Enderby, Blaby – Warren Park Way/ Mill Hill Junction – Stage 1 Road Safety Audit – Designers Response

LAND SOUTH OF LEICESTER LANE, ENDERBY, LEICESTER

Warren Park Way/B582 Junction Highway Improvements

Road Safety Audit - Stage 1

Title **WARREN PARK WAY / B582
 JUNCTION HIGHWAY
 IMPROVEMENTS**

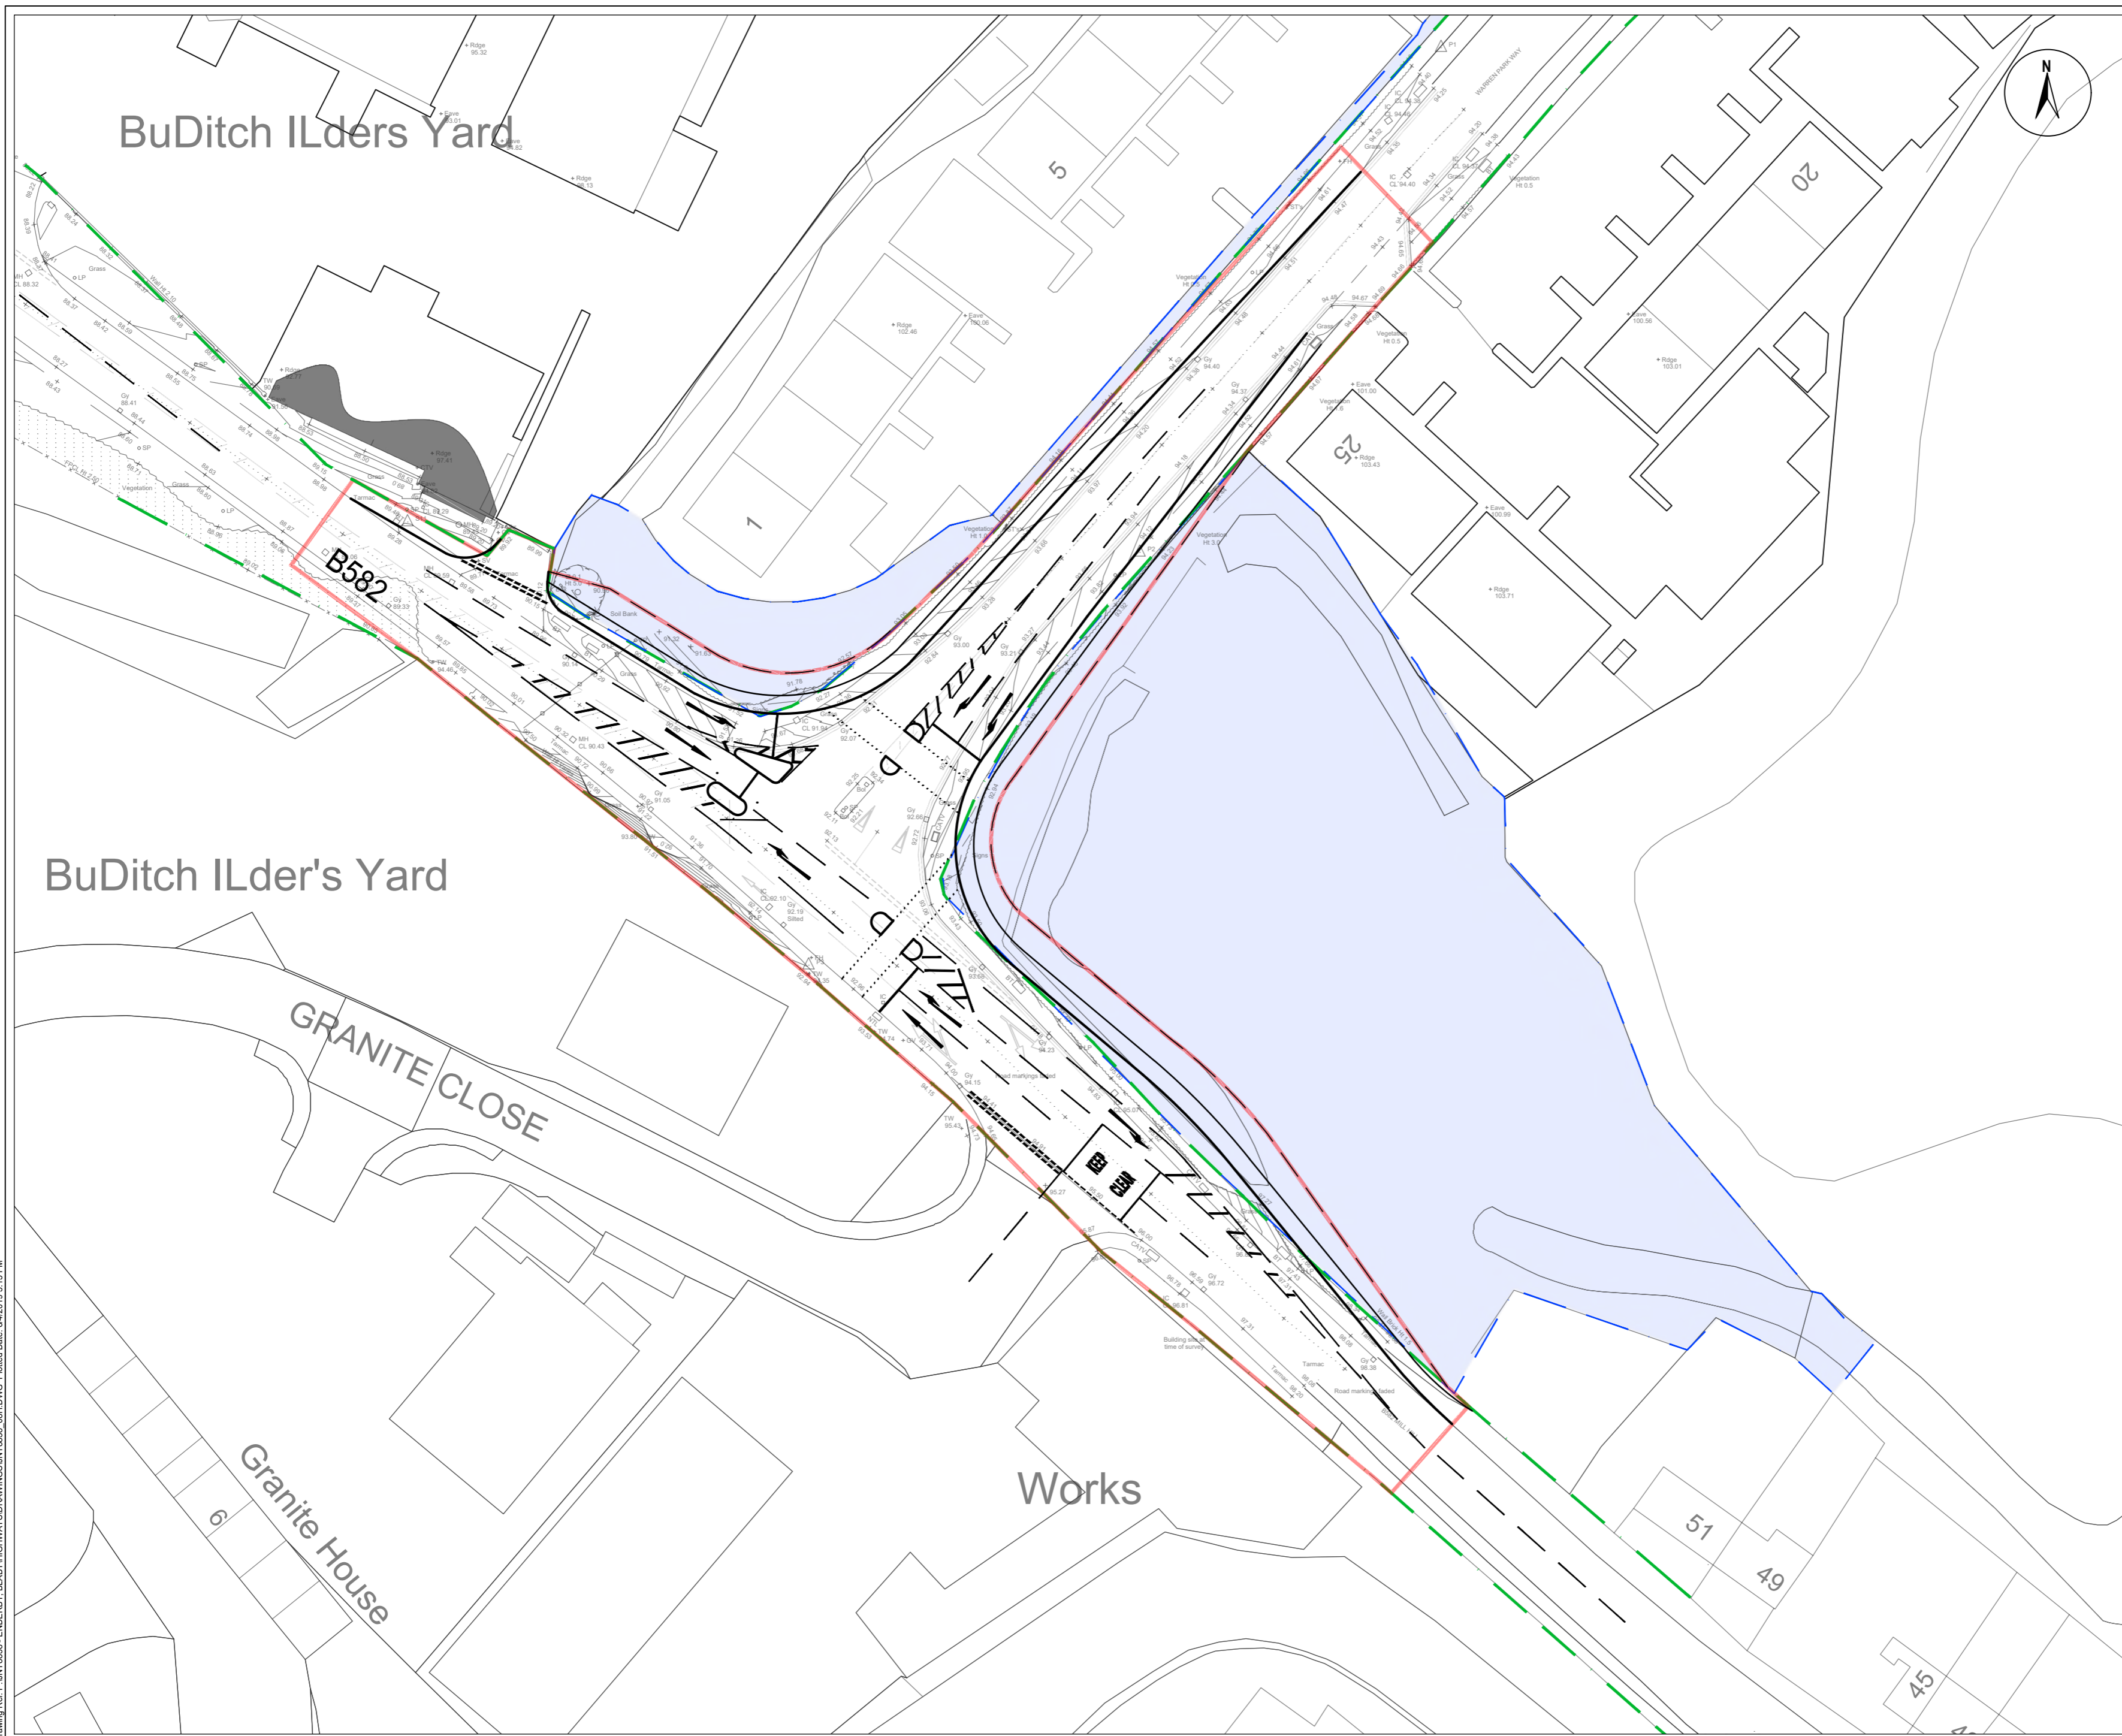
Location 1 - B582 east of Warren Park Way (Drawing No. JNY 8838/08).

Summary - Insufficient right turn width at the Granite Close junction.

Detail - The drawings do not show the proposed lane widths ,however the right turn lane appears to narrow the closer it reaches the Granite Close junction. This junction is used by Heavy Goods Vehicles and a reduction in width of the ghost island may not accommodate large vehicles at this location. This may result in large vehicles straddling the ghost island with the risk that vehicles travelling ahead in an eastbound direction may collide with the rear of vehicles waiting to turn right into Granite Close.

The Audit Team recommends that the right turn lane ghost island is of sufficient width to safely accommodate Heavy Goods Vehicles.

Location 2 - The Warren Park Way Traffic signal controlled junction (Drawing No. JNY 8838/08).

Summary - Insufficient skidding resistance of carriageway surfacing for approaches to traffic signals.

The Audit Team recommends that the for the next stage of audit, the Design Team specifies sufficient carriageway surface skidding resistance for the approaches to the signalised junction such that it meets the current guidance for a “stress” site.

Location 3 - The Warren Park Way Traffic signal controlled junction (Drawing No. JNY 8838/08).

Summary - Proposed traffic signal junction phasing and layout.

The Audit Team recommends that traffic signal information should be provided at the detailed design stage to enable an analysis of potential conflicts to be identified.

Location 4 - The Warren Park Way Traffic signal controlled junction (Drawing No. JNY 8838/08).

Summary - Insufficient forward visibility to the offside signal head.

Detail - The westbound approach to the Warren Park Way junction is along a very steep downhill gradient. If large vehicles are waiting within the right turn lane for Granite Close, the driver visibility to the offside traffic signal head may be obscured. This may increase the risk of vehicle to vehicle rear end shunt type collisions if they brake hard at the stop line.

The Audit Team recommends that additional traffic signal heads are provided together with speed discrimination loops for the westbound approach to the signal controlled junction.

Location 5 - B582 east of Warren Park Way (Drawing No. JNY 8838/08).

Summary - Abrupt nearside kerb alignment forces vehicles to cross median hatch markings into opposing traffic.

Detail - The proposed eastbound nearside kerb alignment at the Granite Close junction appears to introduce an abrupt change of direction for vehicles travelling along the B582. This alignment may force vehicles to cross the existing hatch markings into opposing traffic and may increase the risk of vehicle to vehicle head on type collisions.

The Audit Team recommends that the tight radius is eased to enable a smooth alignment through the junction.

Location 6 - B582 j/w Warren Park Way (Drawing No. JNY 8838/08).

Summary - Insufficient width to accommodate Heavy Goods Vehicles (HGV's) Right Turning movements into B582.

Detail - The Vehicle Swept Paths for HGV's turning right from Warren Park Way into the B582 appear to be extremely tight confirming that the vehicle body path touches the splitter island to the west of Warren Park Way. This may increase the risk of vehicle to street furniture type collisions.

The Audit Team recommends that the turning movements of HGV's can be safely accommodated without hitting street furniture on the splitter islands on the B582.

Location 7 - Left turn from B582 to Warren Park Way (Drawing No. JNY 8838/08).

Summary - Failure to stop at Traffic signals.

Detail - The proposed stop line for vehicles turning left into Warren Park Way from the B582 does not extend between kerbs. This may encourage motorised two wheeled vehicles to ignore the stop line and continue into the side road with a risk of vehicle to vehicle type collisions with vehicles turning right into Warren park Way.

The Audit Team recommends that the stop line at the traffic signals along the B582 extends between kerbs.

Location 8 - Right turn from B582 to Warren Park Way (Drawing No. JNY 8838/08).

Summary - Wide westbound lane encourages vehicle overtaking.

Detail - The proposed right turn lane into Warren Park Way is slightly offset to the north. This leaves a wide area of carriageway that would allow two vehicles to travel ahead in a westbound direction before the lane widths narrow over a short distance. This may increase the risk of vehicle to vehicle side swipe type collisions beyond the Warren park way junction.

The Audit Team recommends that the right turn lane should not give the appearance of being offset and the lane markings for the ghost right turn lane should be adjusted accordingly.

Location General - Throughout the length of proposed highway works (Drawing No. JNY 8838/08).

Summary - Existing street lighting columns within the existing footways are likely to be located in the carriageway where they may be vulnerable to vehicle strikes.

Detail - The proposed works indicate that the B582 is to be widened along the northern side. There are existing street lighting columns along the B582. Street lighting proposals have not been provided for this stage 1 Road Safety Audit and it is unclear where the lighting columns will be finally located.

The audit team is concerned that after carriageway widening if the columns are not carefully located that they may restrict the proposed footway width and form an obstruction to pedestrians that may affect the safe passage of pedestrians along the route with the risk of forcing pedestrians to walk in the carriageway where they would be at risk of being hit by vehicles.

The Audit Team recommends that at the Detailed Design stage of the project, the street lighting columns should be located towards the rear of the footway.

Audit Ref	Problem Summary and Recommendation	Designers Response
2.1.1	<p>Summary: Insufficient right turn width at the Granite Close junction.</p> <p>Detail: The drawings do not show the proposed lane widths, however the right turn lane appears to narrow the closer it reaches the Granite Close junction. This junction is used by Heavy Goods Vehicles and a reduction in width of the ghost island may not accommodate large vehicles at this location. This may result in large vehicles straddling the ghost island with the risk that vehicles travelling ahead in an eastbound direction may collide with the rear of vehicles waiting to turn right into Granite Close.</p> <p>Recommendation: The Audit Team recommends that the right turn lane ghost island is of sufficient width to safely accommodate Heavy Goods Vehicles.</p>	<p>Recommendation accepted. The width of the right turn lane has been increased to 3m. There is sufficient overall lane width to widen this further if required.</p>

2.1.2	<p>Summary: Insufficient skidding resistance of carriageway surfacing for approaches to traffic signals.</p> <p>Detail: The drawings do not show what type of surface material is to be laid at this stage of audit. A lack of adequate skidding resistance to the carriageway surfacing may increase the risk of vehicles failing to stop when red lights are present, especially during wet conditions. This may increase the risk of vehicles to non-motorised users type collisions.</p> <p>Recommendation: the Audit Team recommends that for the next stage of audit, The Design Team specifies sufficient carriageway surface skidding resistance for the approaches to the signalised junction such that it meets the current guidance for a 'stress' site.</p>	<p>Recommendation accepted. This will be reviewed at the Detail Design Stage.</p>

2.1.3	<p>Summary: Proposed traffic signal junction phasing and layout.</p> <p>Detail: The proposed phasing of the signalised junction has not been supplied as part of this stage of this stage 1 Road Safety Audit. It will be important to ensure that sufficient checks are made to establish that potential movement conflicts are minimised to reduce the risk of collision by opposing traffic movements.</p> <p>Recommendation: The Audit Team recommends that traffic signal information should be provided at the detailed design stage to enable an analysis of potential conflicts to be identified.</p>	<p>Recommendation accepted. Detailed analysis has been carried out as part of the Transport Assessment.</p>

2.1.4	<p>Summary: Insufficient forward visibility to the offside signal head.</p> <p>Detail: The westbound approach to the Warren Park Way junction is along a very steep downhill gradient. If large vehicles are waiting within the right turn lane for Granite Close, the driver visibility to the offside traffic signal head may be obscured. This may increase the risk of vehicle to vehicle rear end shunt type collisions if they brake hard at the stop line.</p> <p>Recommendation: The Audit Team recommends that additional traffic signal heads are provided together with speed discrimination loops for the westbound approach to the signal controlled junction.</p>	<p>Recommendation accepted. This will be reviewed at the detail design stage.</p>

2.2.1	<p>Summary: Abrupt nearside kerb alignment forces vehicles to cross median hatch markings into opposing traffic.</p> <p>Detail: The proposed eastbound kerbside kerb alignment at the Granite Close junction appears to introduce an abrupt change of direction for vehicles travelling along the B582. This alignment may force vehicles to cross the existing hatch markings into opposing traffic and may increase the risk of vehicle to vehicle head on type collisions.</p> <p>Recommendation: The Audit Team recommends that the tight radius is eased to enable a smooth alignment through the junction.</p>	<p>Recommendation agreed. The alignment has been adjusted to provide a smoother radii.</p>

2.2.2	<p>Summary: Insufficient width to accommodate Heavy Goods Vehicles (HGV's) Right Turning movements into B582</p> <p>Detail: The Vehicle Swept Paths for HGV's turning right from Warren Park Way into the B582 appear to be extremely tight confirming that the vehicle body path touches the splitter island to the west of Warren Park Way. This may increase the risk of vehicle to street furniture type-collisions.</p> <p>Recommendation: The Audit Team recommends that the turning movements of HGV's can be safely accommodated without hitting street furniture on the splitter islands on the B582.</p>	<p>Recommendation Accepted.</p> <p>The tracking shows that a max legal can safely manouvre through the junction without affecting the traffic islands, however to allow more room for large vehicle turning right from Warren Park Way, the island width has been reduced from 2m to 1.8m, this is a traffic island and will not accommodate pedestrian movements therefore this is considered acceptable. This ensures that there is 0.5m between the body of the vehicle and the island.</p>

2.5.1	<p>Summary: Failure to stop at Traffic Signals</p> <p>Detail: The proposed stop line for vehicles turning left into Warren Park Way from the B582 does not extend between kerbs. This may encourage motorized two wheeled vehicles to ignore the stop line and continue into the side road with a risk of vehicle to vehicle type collisions with vehicles turning right into Warren Park Way.</p> <p>Recommendation: The Audit Team recommends that the stop line at the traffic signals along the B582 extends between the kerbs.</p>	<p>Recommendation accepted. The stop line has been extended to the kerb line.</p>

2.5.2	<p>Summary: Wide westbound lane encourages vehicle overtaking.</p> <p>Detail: The proposed right turn lane into Warren Park Way is slightly offset to the north. This leaves a wide area of carriageway that would allow two vehicles to travel ahead in a westbound direction before the lane widths narrow over a short distance. This may increase the risk of vehicle to vehicle side swipe type collisions beyond the Warren Park Way junction.</p> <p>Recommendation: The Audit Team recommends that the right turn lane should not give the appearance of being offset and the lane markings for the ghost right turn lane should be adjusted accordingly.</p>	<p>Recommendation accepted. The road markings have been corrected.</p>

<p>2.5.3</p>	<p>Summary: Existing street lighting columns within the existing footways are likely to be located in the carriageway where they may be vulnerable to vehicle strikes.</p> <p>Detail: The proposed works indicate that the B582 is to be widened along the northern side. There are existing street lighting columns along the B582. Street lighting proposals have not been provided for this stage 1 Road Safety Audit and it is unclear where the lighting columns will be finally located.</p> <p>The Audit team is concerned that after carriageway widening if the columns are not carefully located that they may restrict the proposed footway width and form an obstruction to pedestrians that may affect the safe passage of pedestrians along the route with the risk of forcing pedestrians to walk in the carriageway where they would be at risk of being hit by vehicles.</p> <p>Recommendation: The Audit Team recommends that at the Detailed Design stage of the project, the street lighting columns should be located towards the rear of the footway.</p>	<p>Recommendation accepted. The lighting at this junction will be reviewed at the Detail Design Stage.</p>
